III. RESPONSE TO COMMENTS

The Draft EIR for the Harbor Gateway Center project was distributed for public review between February 6, 1997 and March 24, 1997. During the public review period, a total of 16 comment letters pertaining to the DEIR were received by the City of Los Angeles Department of City Planning. Each comment raised in these letters is responded to in this section of the Final EIR. The letters received during the public review period included the following:

Draft Environmental Impact Report		SUMMARY OF COMMENTS ON DRAFT EIR																									
Harbor Gateway Center

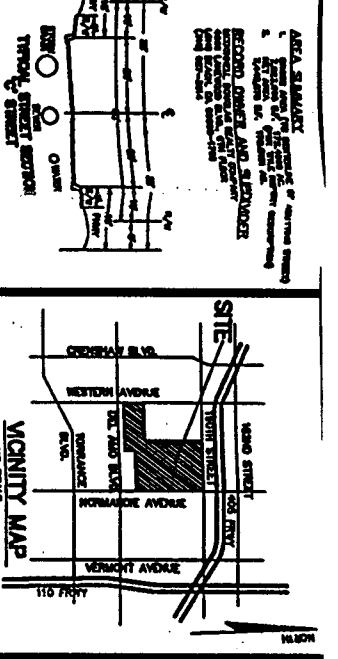
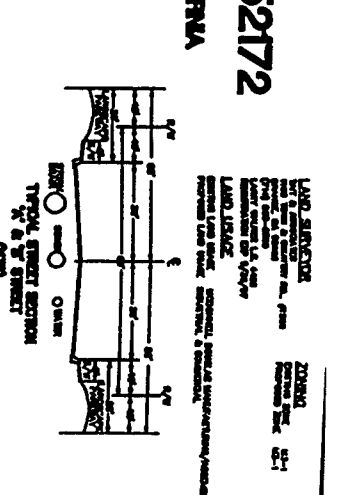
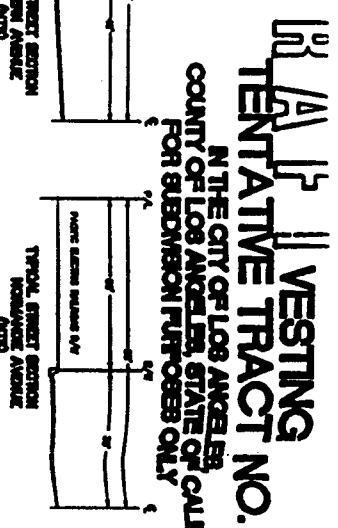
Related to the realignment of A Street is a refinement to the plans for C Street. Its western terminus will occur as a cul-de-sac to facilitate the future extension of 195th Street from Western Avenue to Normandie Avenue as shown on the conceptual Alternative 2 plan (Master Planned Block Development) in the DEIR (i.e., the cul-de-sac would be removed to provide a through way). If this extension of 195th Street occurs, the northern segment of A Street, between C Street and West 190th Street, may be terminated. The proposed intersection of A Street and West 190th Street would remain to provide controlled access to/from the retail portion of the Project.

These refinements to the proposed circulation system do not constitute a significant change under CEQA, and do not alter the overall analysis and conclusions of the DEIR. The essence of the Project, as addressed in the DEIR, remains unchanged.

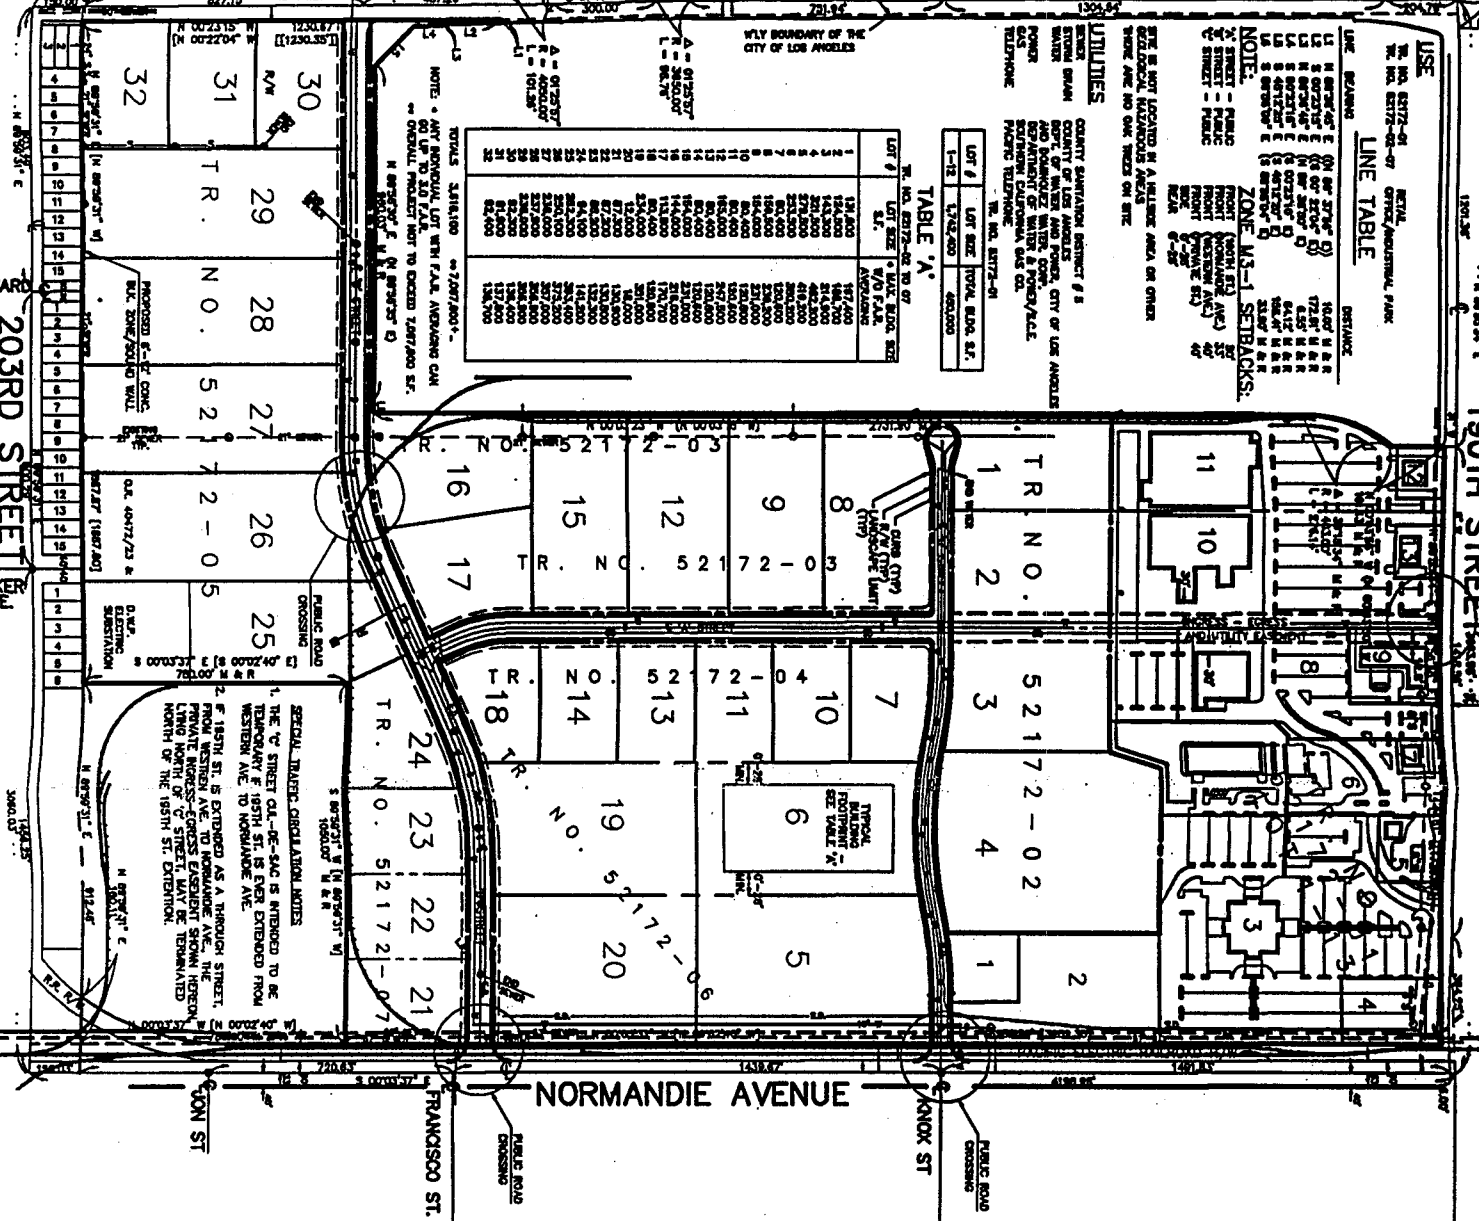
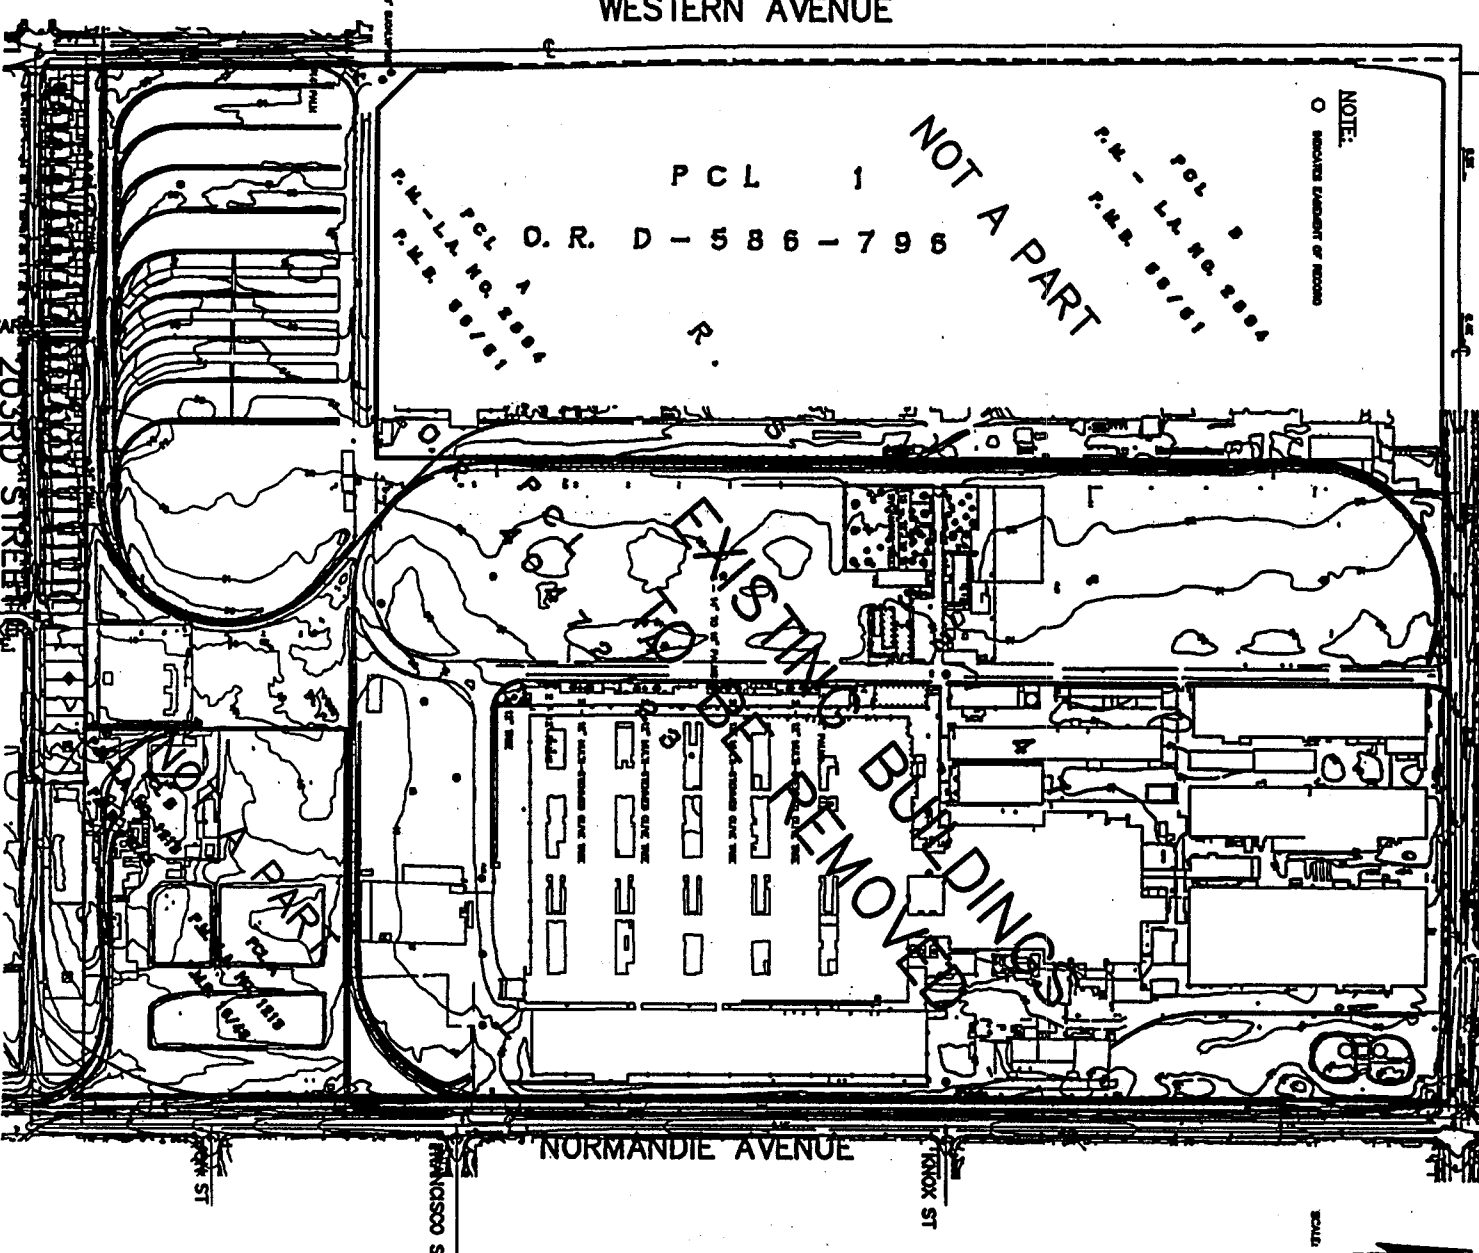
2. Retail Area Configuration - The easterly portion of the proposed retail center has been extended south to C Street. The total retail building retail floor area potentially would still not exceed the 450,000 square feet assumed for the impacts analysis of the DEIR. As such, this Project refinement would not alter the overall analysis and conclusions of the DEIR.

Clarification Regarding Public Road Crossing of Existing Rail Lines - In addition to the proposed development of two new rail crossings, as shown in Figure 10 of the DEIR, approval of a public road crossing by the California Public Utilities Commission (PUC) will be sought for the existing crossing (shown in Figure 2 of the DEIR) on B Street just west of that Street's intersection with A Street. Such crossing is depicted on Figure 10, but needs to be appropriately labeled in the Final EIR.

PROJECT VOLUMES

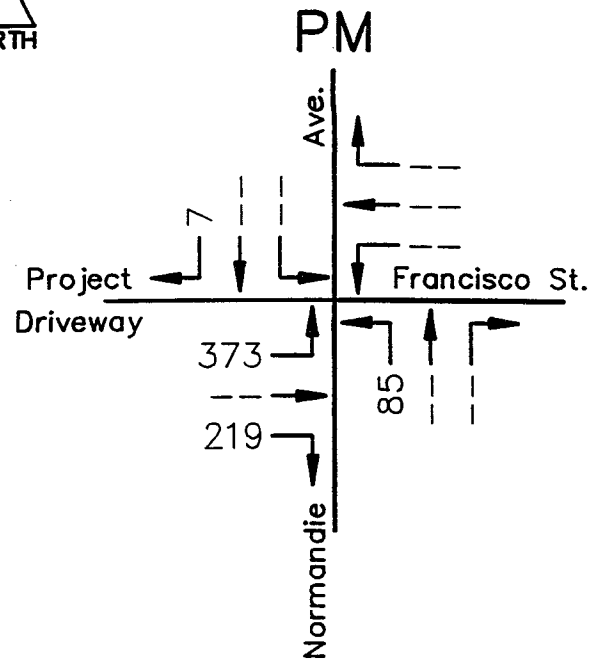
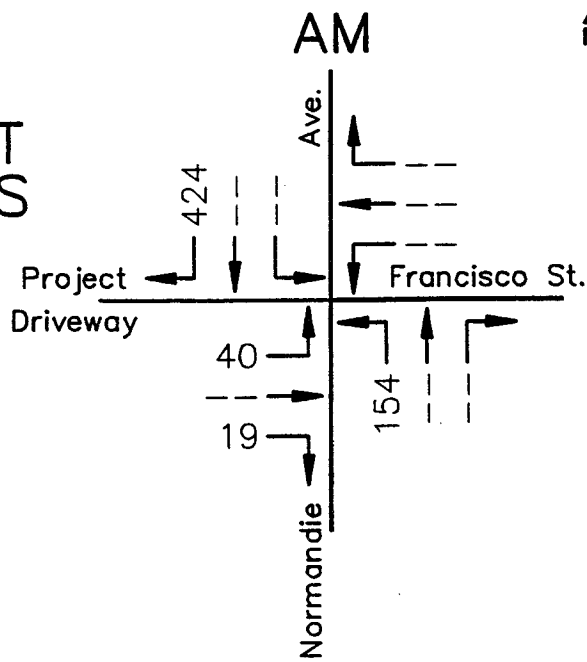
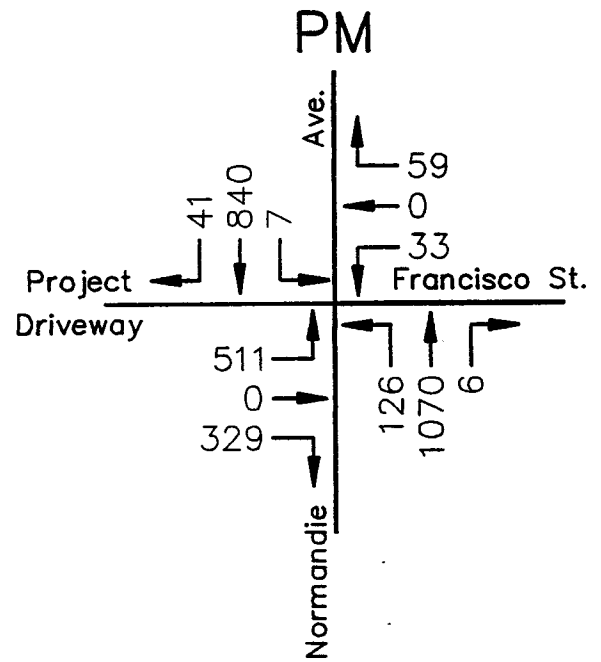
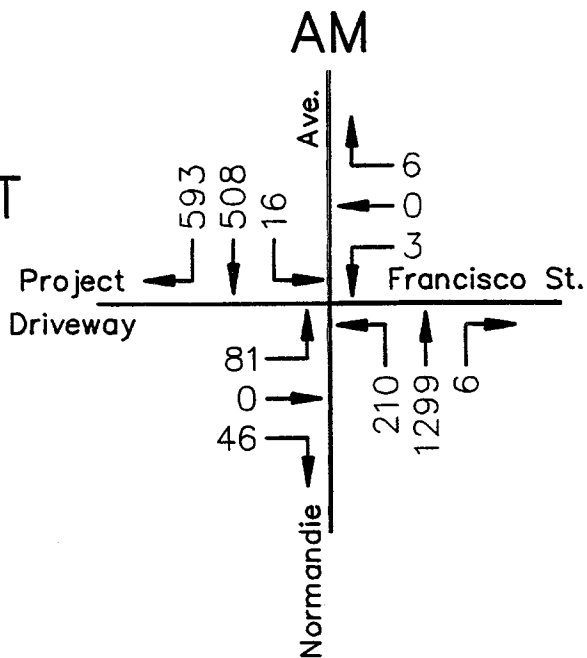
Page 25 The project traffic volumes shown on Figures 4a and 4b raise several questions. It appears that the percentage of traffic oriented toward the freeway system is 35-41% of project trips in the AM peak hour (531 inbound trips are illustrated exiting the freeway and 59 outbound trips are shown entering the freeway on Figure 4a) and 42-49% in the PM peak hour (265 inbound trips and 527 outbound trips access the freeways in Figure 4b). An explanation should be provided as to why these percentages vary by time of day, given the single trip distribution referenced in Table 6. It also appears that the assignment of project
